Docket Number:	13-AFC-01
Project Title:	Alamitos Energy Center
TN #:	212764-4
Document Title:	Attachment 3 - Tidal Influence Final Memo Re - AES PSA Aug 2016
Description:	N/A
Filer:	ELIZABETH LAMBE
Organization:	Los Cerritos Wetlands Land Trust
Submitter Role:	Intervenor
Submission Date:	8/12/2016 11:53:41 AM
Docketed Date:	8/12/2016

Memorandum

Subject: Review of the Alamitos Energy Center Preliminary Staff Assessment

Exhibit A

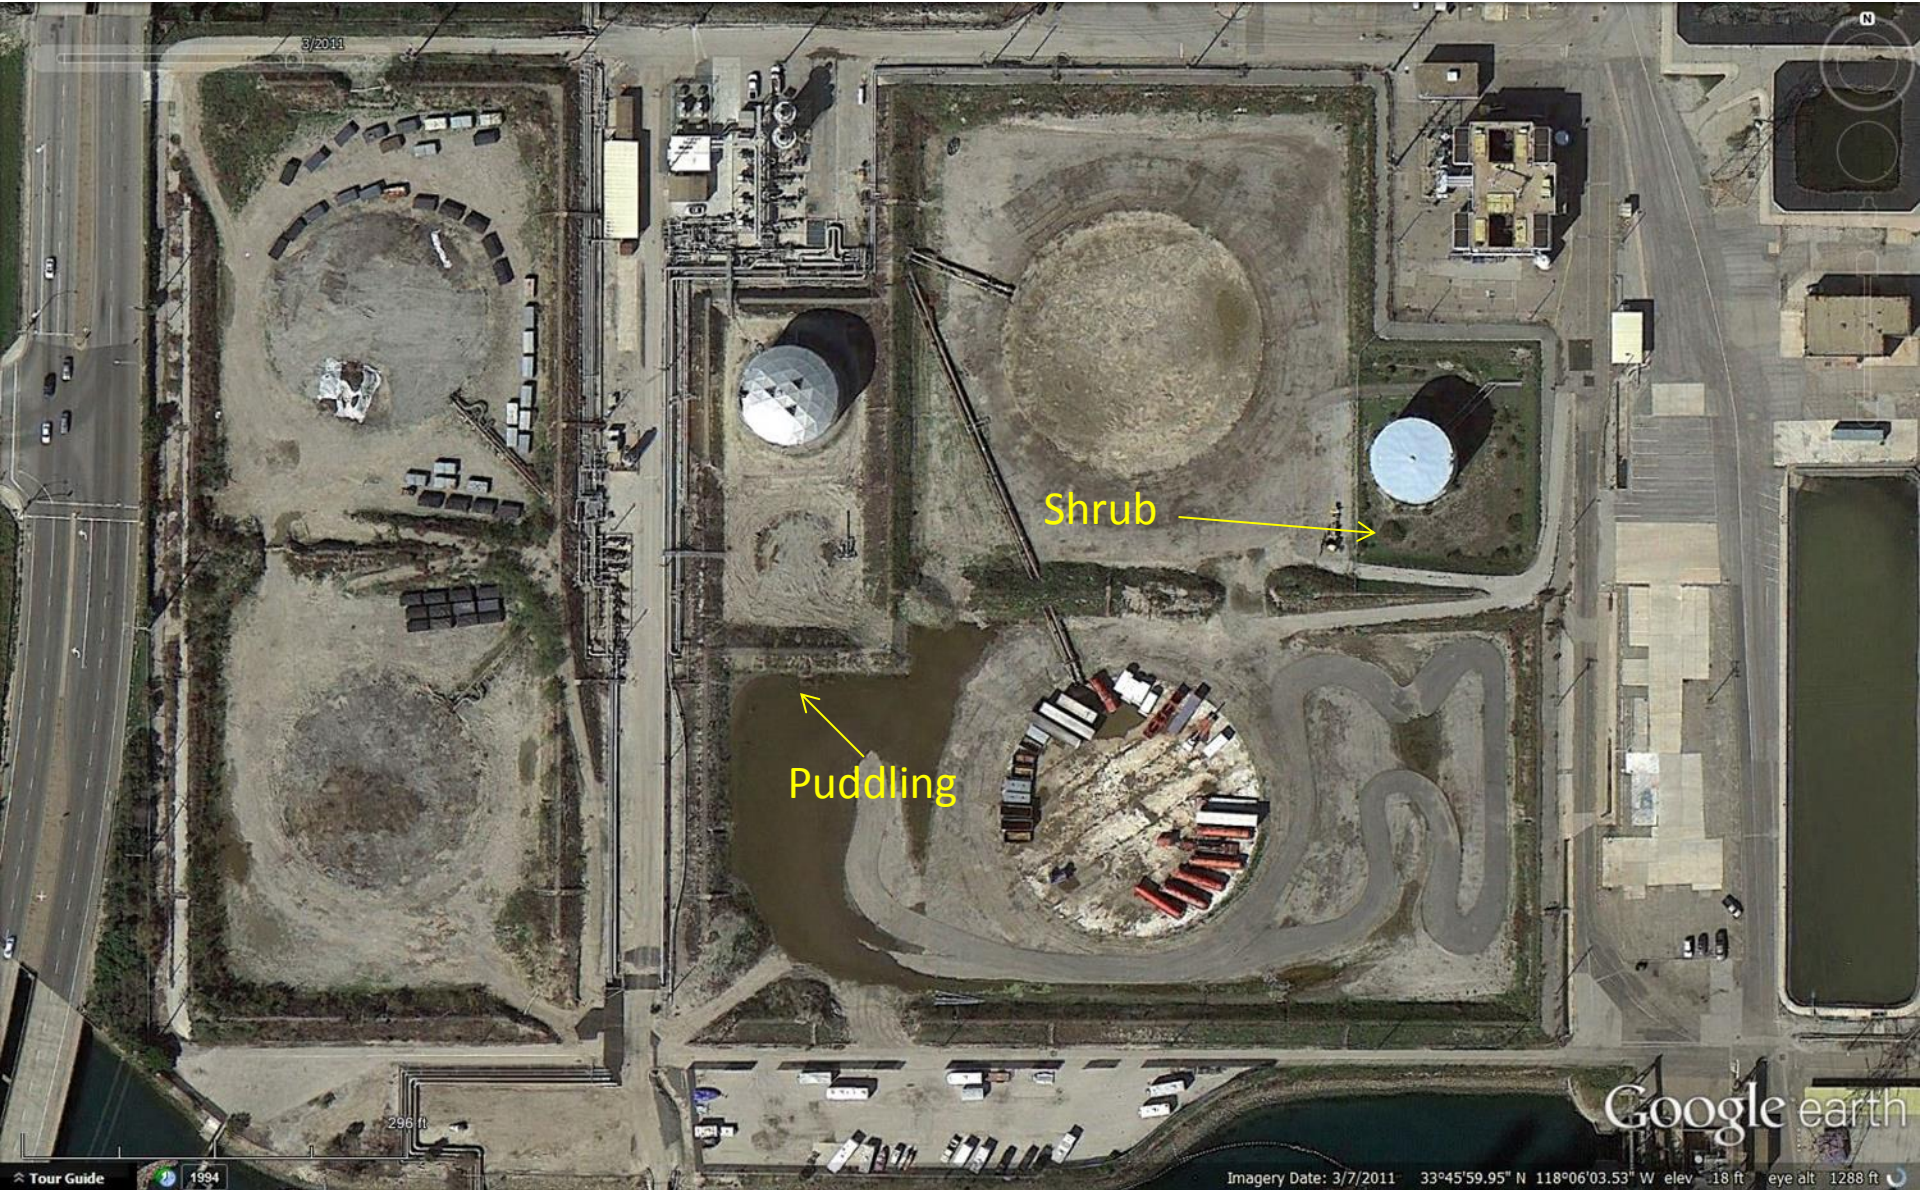
Additionally, if staff believes that the white-tailed kite (*Elanus leucurus*) has a “moderate” potential to occur, then we recommend that the short-eared owl (*Asio flammeus*), northern harrier (*Circus cyaneus*), and loggerhead shrike (*Lanius ludovicianus*) all should be listed as “moderate” as well. Through the analysis of historic aerial photos it appears that the site becomes vegetated each year in the spring and puddling also occurs. Also, the adjacent former tank farm site has become progressively more vegetated since the tanks were demolished in 2010, which undoubtedly has attracted more wildlife to the immediate vicinity. The staff assessment references the annual existence of ruderal vegetation on page 4.3-8 and further mentions its existence on page 4.3-24 where the presence of “temporary puddles” is also mentioned. Regardless of the “temporary” status of the vegetation and puddling, there is potential that they both could temporally attract prey for the short-eared owl, northern harrier and loggerhead shrike and that the project site may occasionally be visited by these species during these temporary periods when the site is vegetated or flooded. In Exhibit A we present a series of historic aerial photos that demonstrate the site was recently cleared of vegetation sometime between March 2015 and February 2016. Several shrubs and extensive vegetation can be seen growing over the years and then disappearing. Since the project is in the coastal zone this type of vegetation management would require a coastal development permit. Otherwise, this work could be considered as an unpermitted modification of the project site done to influence this staff assessment.
